Westinghouse Electric Company LLC
Hematite Decommissioning Project
3300 State Road P
Festus, MO 63028
USA

Subject: PARTIAL RESPONSE TO NRC REQUESTS FOR ADDITIONAL INFORMATION DATED MAY 1, 2012, ON THE JANUARY 16, 2012, HEMATITE 20.2002 ALTERNATE DISPOSAL REQUEST (LICENSE NO. SNM-00033, DOCKET NO. 070-00036)

Enclosure 1
Responses to Requests for Additional Information on
Additional 20.2002 Request for Alternate Disposal at USEI (except MC&A)

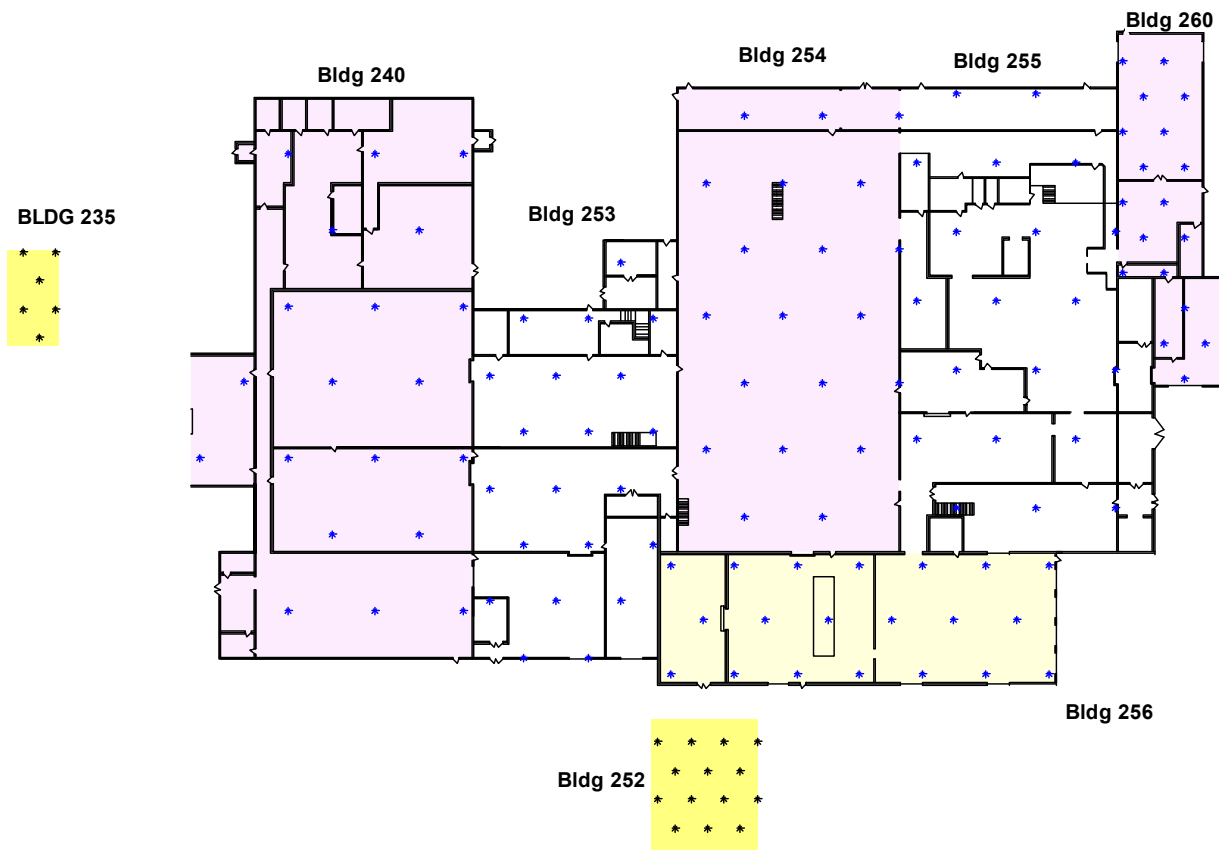
RAI No.	Section	Issue	Regulatory Link	Discussion	Path Forward
CH-6	Section 5.2.1 Soils, and Section 6.5 of HDP-TBD-WM-906	Gamma Walkover is used to inform adequacy of sampling for presence of Tc-99 (beta emitter).	10CFR20.2002(a)	Section 6.5 of HDP-TBD-WM-906 describes how 33 of the 50 samples were targeted in and around areas of elevated activity based on the gamma walkover survey, and the remaining 17 locations were dispersed throughout the remainder of the building. It also explains that areas in which Tc-99 was known to be present, based on historical information, were included in the targeted sampling within Buildings 240 and 260. Since Tc-99 would not be detected by a gamma walkover survey, and there is not an established ratio for Tc-99 to uranium, Westinghouse should describe the adequacy of the sampling locations in terms of detecting any Tc-99 in the material that may not have coincided with areas of elevated gamma readings.	Provide the basis that no areas of Tc-99 have been overlooked given that sample locations were biased based on the gamma walkover survey results.

The following table summarizes the sampling design developed. A figure that shows sampling locations in the field is also provided below.

Figure 1 to Appendix D, Gamma Walkover-GPS Data and Sampling Locations

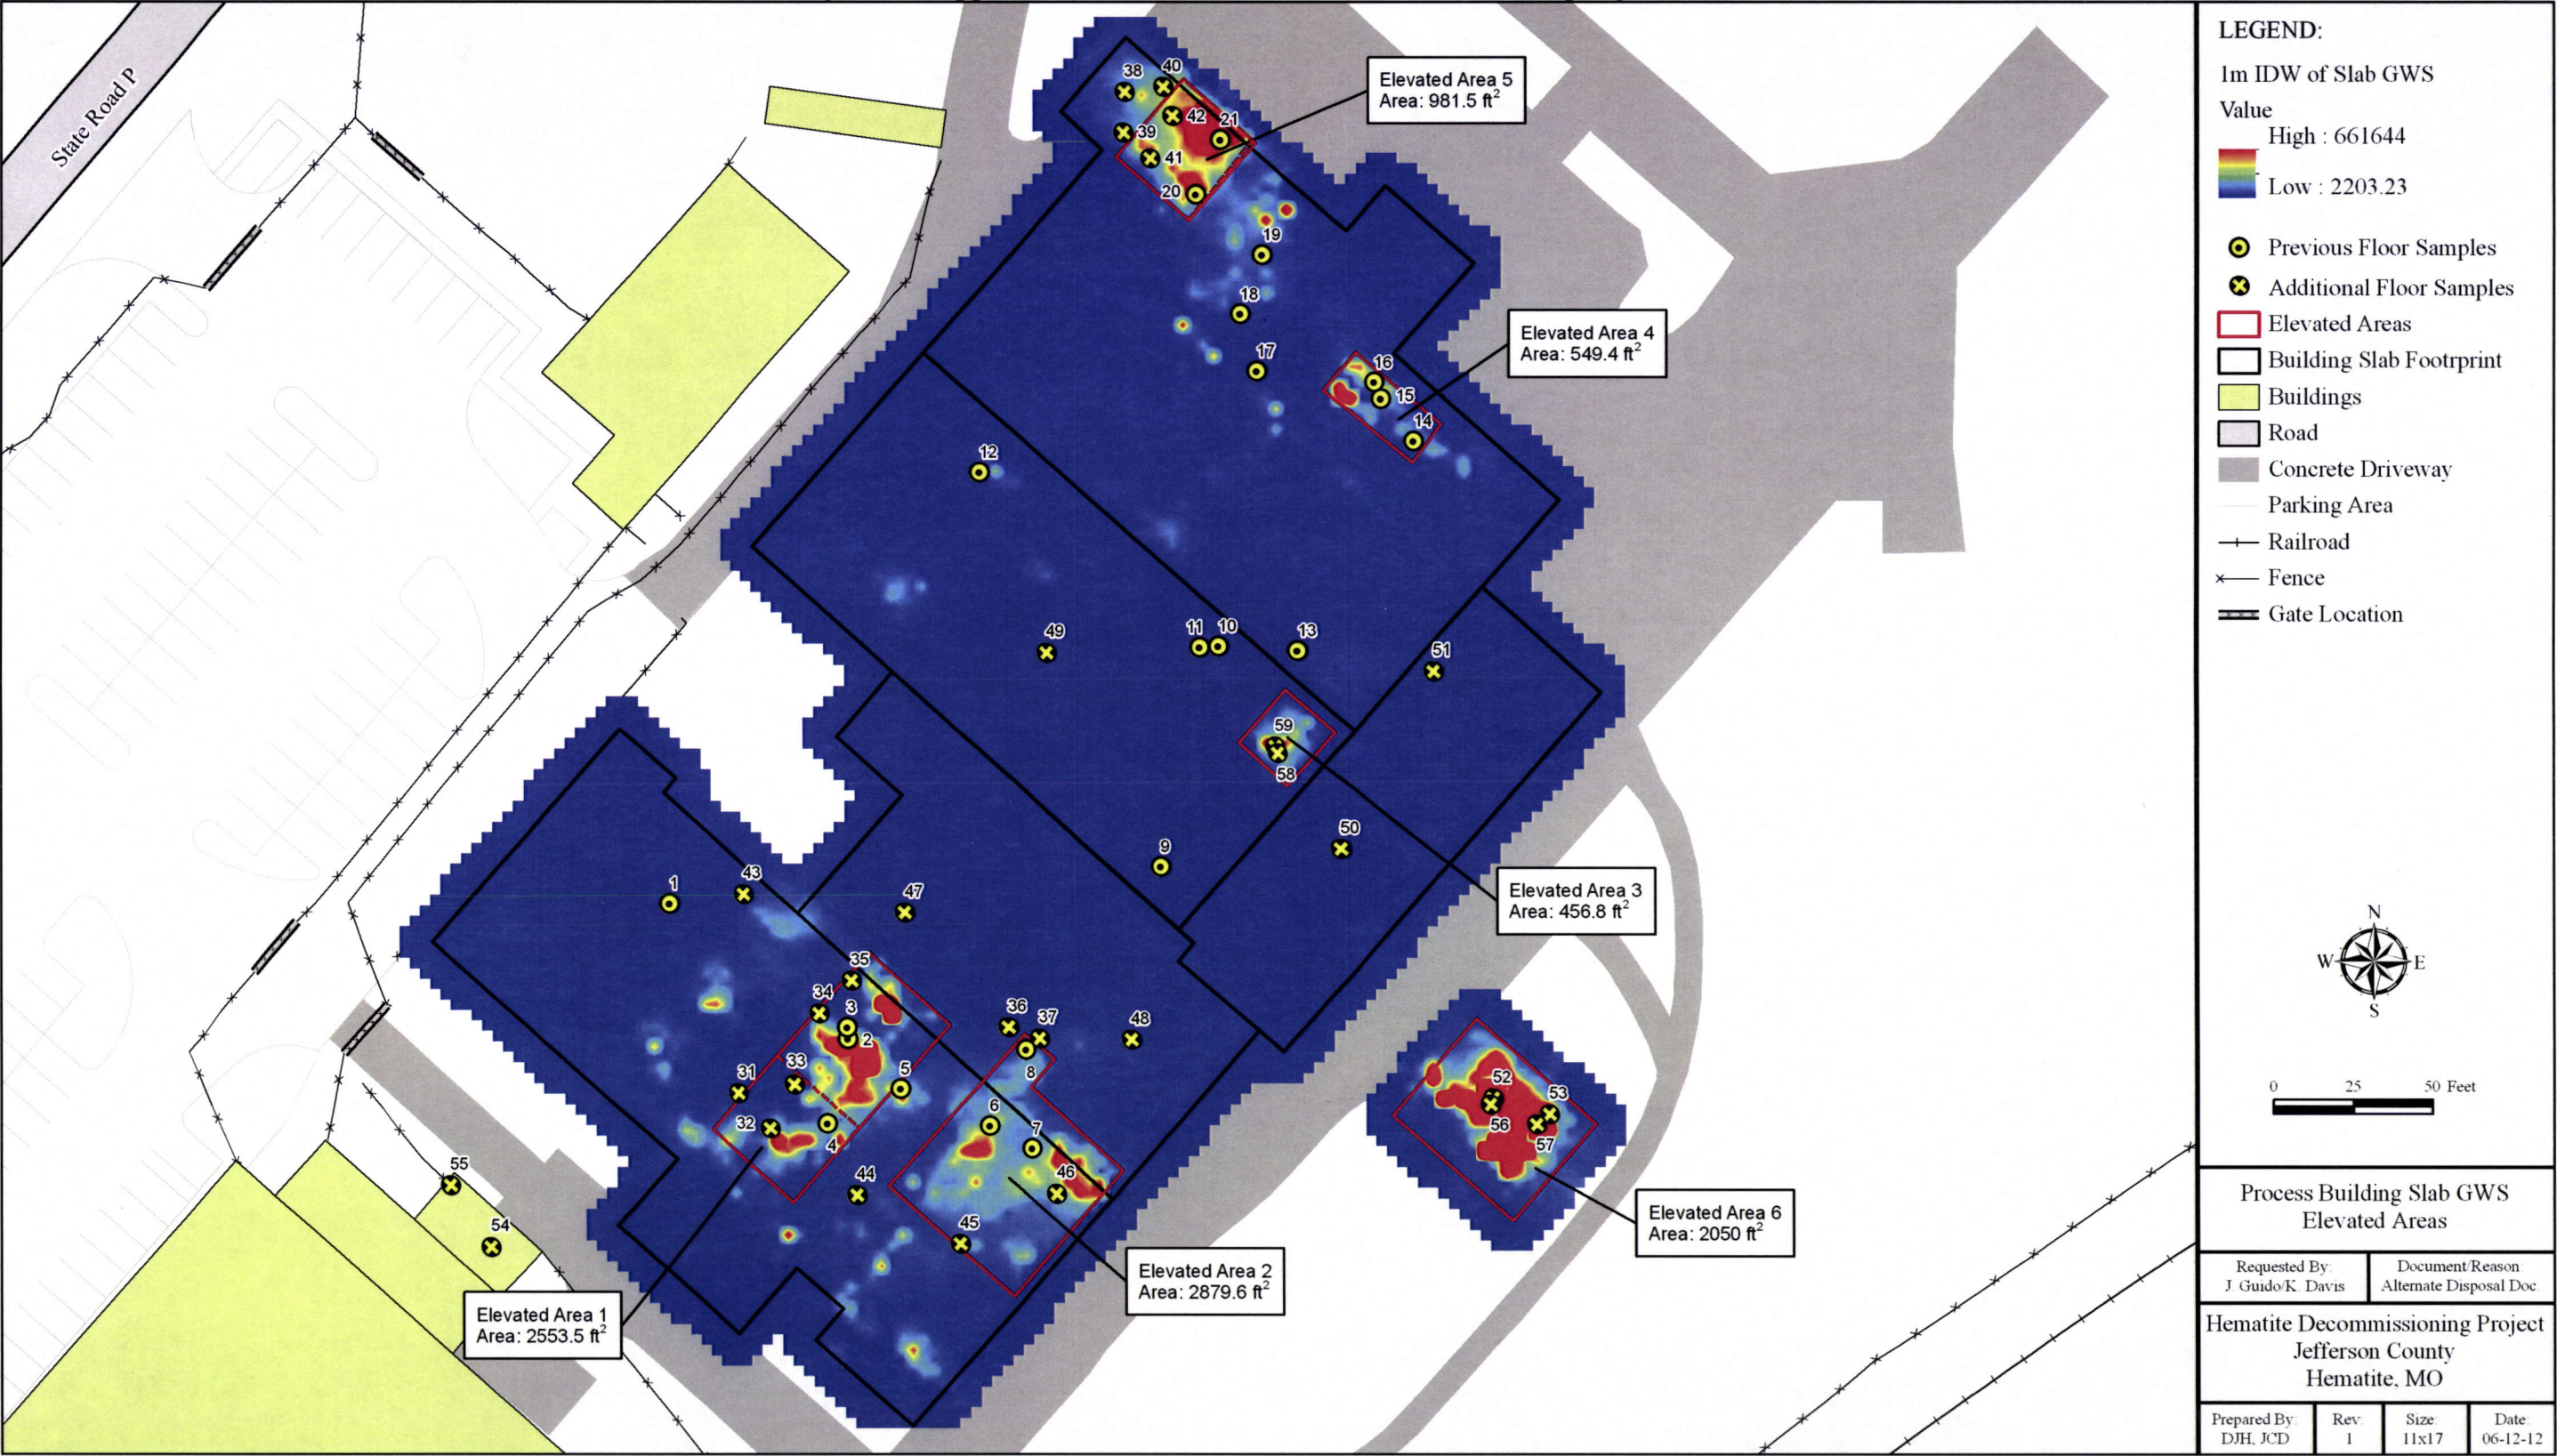
RAI No.	Section	Issue	Regulatory Link	Discussion	Path Forward
CH-9	Section 5.2 Waste Characterization, Section 6.4 of HDP-TBD-WM-906	Inconsistencies in Table 6-2 thru Table 6-4 of HDP-TBD-WM-906 and Fig 1 of Appendix 0 of HDP-TBD-WM-906.	10CFR20.2002(a)	It is not clear how the concentrations for each sample in Table 6-2 are compiled to calculate concentrations for each elevated Area in Table 6-5. This information is necessary to adequately review the characterization data. The information in Appendix D Fig. 1 is not consistent with Tables 6-2 and 6-3, which brings ambiguity in matching location sample number to the correct Area. Section 6.5 states that of 50 samples, 33 were targeted in and around areas of elevated activity and 17 were dispersed through the remainder of the building. From this statement, one would expect Table 6-2 (Elevated Areas) to contain 33 samples (minus the 5 that are excluded), and Table 6-3 (Non-Elevated Areas) to contain 17 samples. However this is not the case. Some samples that are not from areas of elevated activity are in Table 6-3 and some samples that are within areas of elevated activity are not in Table 6-3.	<p>Please identify the location Area (1-6) in Table 6-2. Please describe how the data in Table 6-2 is applied in calculating the data in Table 6-5. Please describe how the data from Table 6-4 (subsurface for Area 3) are incorporated into the average for Area 3. Please also explain the following inconsistencies, and any additional inconsistencies that are discovered in your review, between Tables 6-2, 6-3 and Appendix D Figure 1.</p> <ul style="list-style-type: none"> • Why are samples 1, 10, 13, 17, and 18 listed in Table 6-2 since they are not in one of the marked elevated areas? Why didn't the gamma walkover catch these since they had higher uranium levels? • Why is sample 15 in Table 6-3 if it is inside Area 5? • Why are samples 31-32 in Table 6-3 if they are inside Area 1 (portion that will go to USEI)? • Why are samples 41-42 in Table 6-3 if they are inside Area 5? • Why are samples 45-46 in Table 6-3 if they are inside Area 2? • Why are samples 52-53 in Table 6-3 if they are inside Area 6? • Where are samples 33, 54 and 55 (they are not listed in Fig 1)? • Why is sample 34 included in Table 6-3? Shouldn't it be excluded since this N.E. portion of Area 1 is not going to be sent to US Ecology (as samples 2, 3, and 35 are excluded)?

RAI No.	Section	Issue	Regulatory Link	Discussion	Path Forward
					<ul style="list-style-type: none"> Why isn't sample 37 in Table 6-3? It appears to be just outside of Area 2. It is not in 6-2 or 6-3 and is not listed as excluded in the footnote to Table 6-2.

RAI No.	Section	Issue	Regulatory Link	Discussion	Path Forward
<p><i>Where are samples 33, 54 and 55 (they are not listed in Fig 1)?</i></p> <p>The caption for Sample Station 33 is missing from Figure 1 in Appendix D. Attached is a revised Figure 1 for Appendix D. Sample Station 33 was collected in Building 240, Red Room. Sample Stations 54 and 55 are located on Figure 1 to Appendix D just north of the label for Elevated Area 1. These sample stations are within Building 235, which may be dismantled after its support of other decommissioning activities is finished.</p> <p><i>Why isn't sample 37 in Table 6-3? It appears to be just outside of Area 2. It is not in 6-2 or 6-3 and is not listed as excluded in the footnote to Table 6-2.</i></p> <p>Sample Station 37 should have been included in Table 6-3. See the response to RAI SA-3 for a revised Table 6-3. Since inclusion of Sample Station 37 lowered the average concentration for Table 6-3, subsequent calculations that use the previous Table 6-3 result (e.g., the estimate of building surface activity) are conservative and are not recalculated.</p>
